## Proposal for the 03 series of amendments to UN Regulation No. 79

### I. Proposal

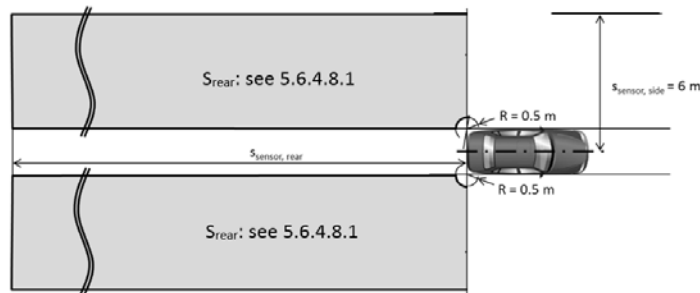
5.6.4.8.2. The vehicle system detection area on ground level shall be at minimum as shown in the figure below.
